PIT5507C Service Park Assist Message At Start Up With DTC U0159 / False Alerts / Park Assist Off Message

Models

This PI was superseded to update the model year, Condition, Recommendation and Parts sections. Please discard PIT5507B.

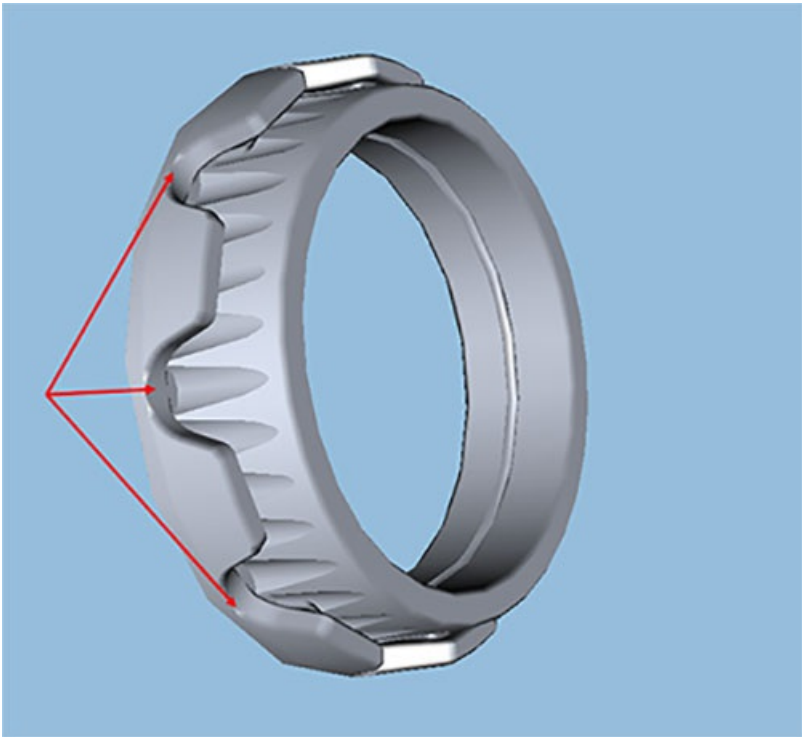
Condition 3 - The 2016-2017 Silverado 1500 and Sierra 1500 models use a new/different style front park assist sensor ring, which is scalloped, as shown below. There have been reports of replacement front park assist sensors coming with the incorrect sensor ring, which do NOT have the scallops. If the wrong sensors rings (withOUT the scallops) are installed, it will cause unwanted/false front park assist alerts. This can cause the system to display the "Park Assist Off" message.

Remove the front park assist sensor(s) and inspect the sensor rings for the scallops molded into the ring, as shown below. If there are no scallops molded into the ring, the wrong sensor ring(s) are installed. Replace the sensor ring(s) with GM part number 84075328, which is the new scalloped design.

It is imperative when installing the sensor rings to pay close attention that the sensor and ring are properly installed. If the sensor and ring are not properly installed and there is binding/misalignment/etc. of the sensor/ring, it will continue to cause unwanted/false alerts.
